CITY OF VANCOUVER
COMMUNITY SERVICES GROUP

DEVELOPMENT PERMIT STAFF COMMITTEE REPORT
DECEMBER 17, 2014

803 WEST 12TH AVENUE (COMPLETE APPLICATION)
DE416467 - ZONE CD-1

DRAWN 18	CHECKED AP
SCALE 1/8" = 1'-0"	DATE SEPTEMBER 14, 2014
PROJECT NO. 14001	DRAWING NO. L3.4

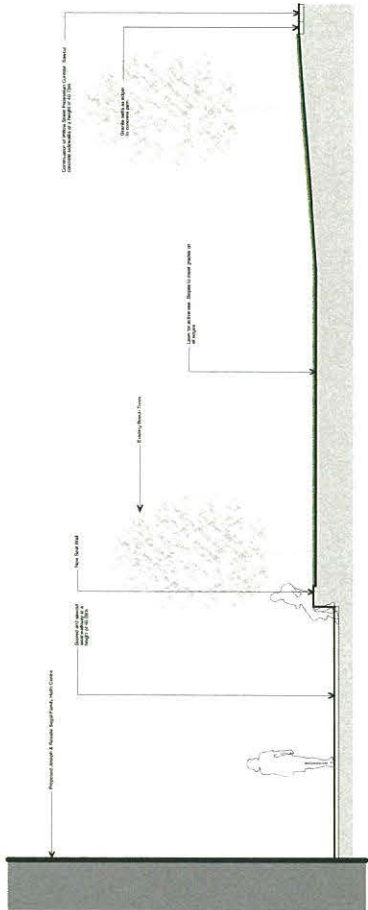
A.2.3 provide a revised sidewalk detail indicating saw cut control joints to replace MF137-F-2 on drawing L 3.3 to indicate saw cut control joints to replace trowelled joints;

Obligation and Phases of VGC Development

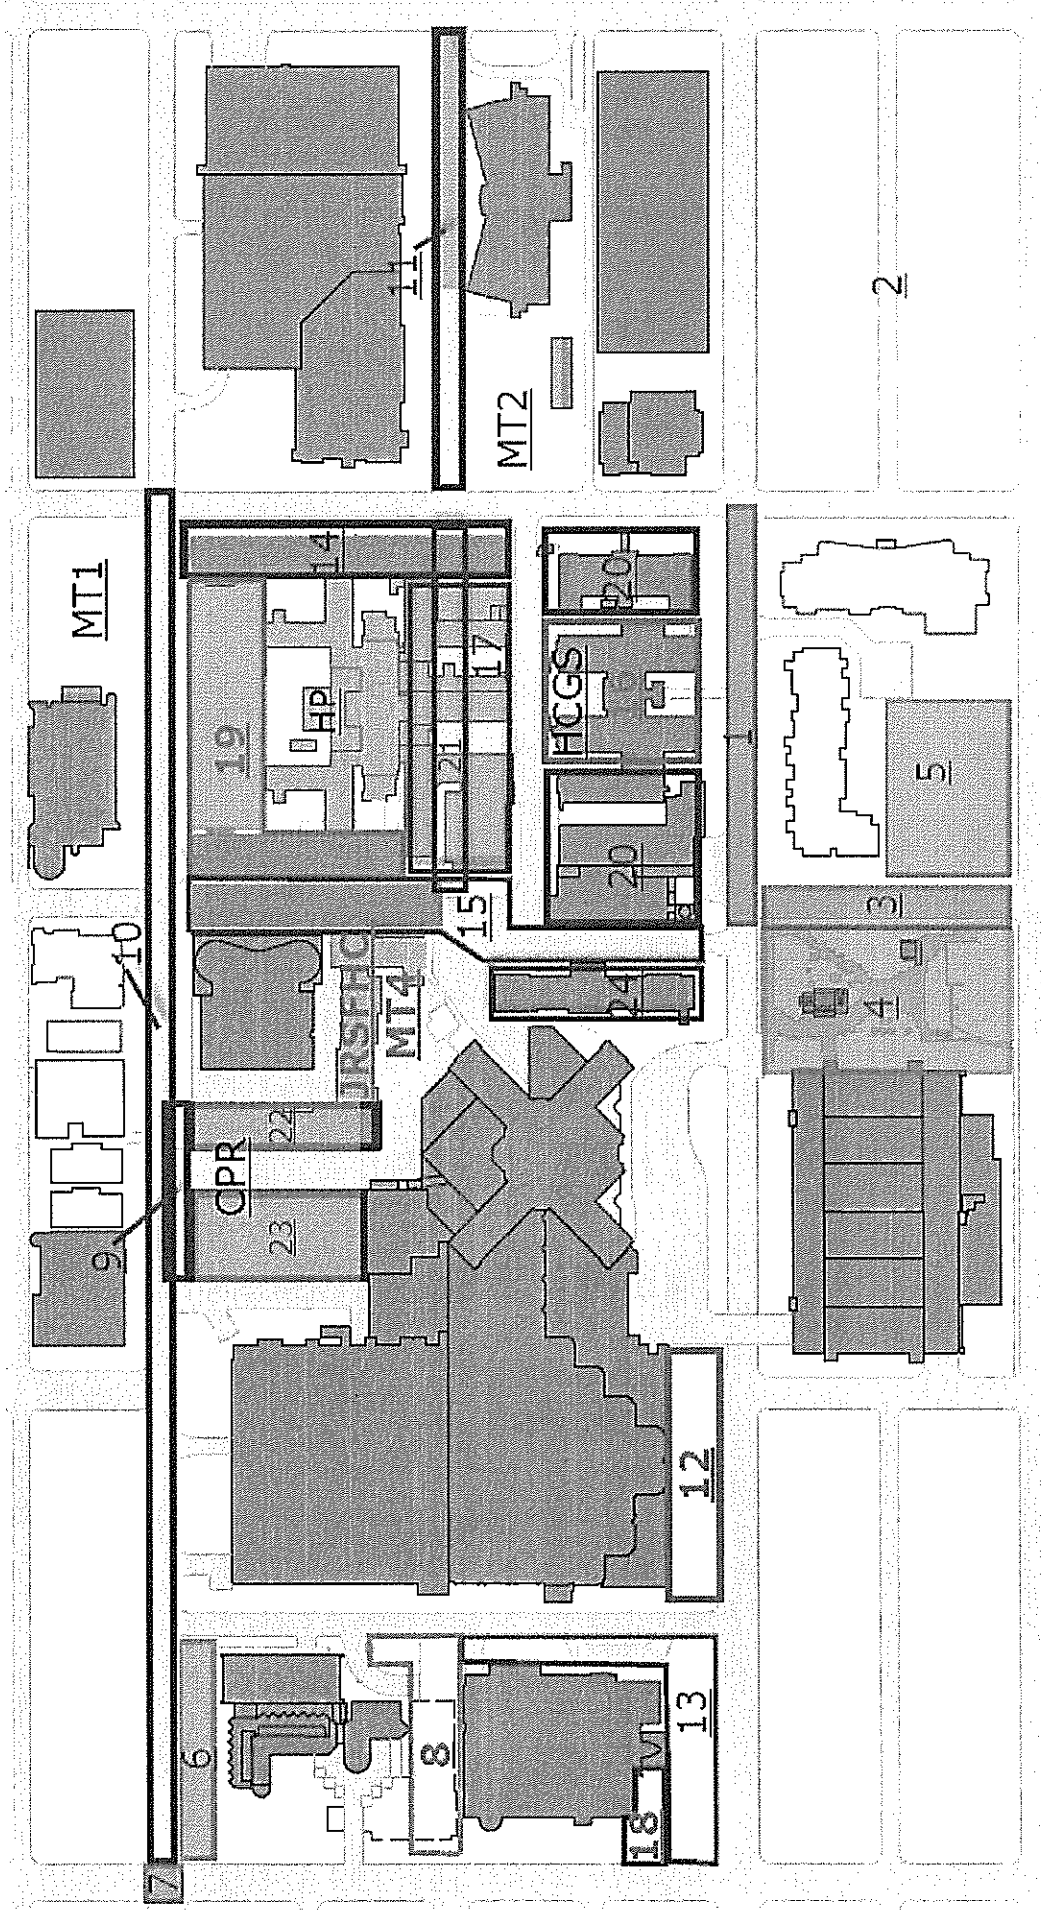
- 1.4 demolition of the current health care building on West 12th Avenue noted in Appendix I as area 16; and the provision of green and landscaped open spaces compatible in design with the approved Master Plan in area 16, the west portion of area 19, and the north half of area 15, all to the satisfaction of the Director of Planning and the General Manager of Engineering Services;
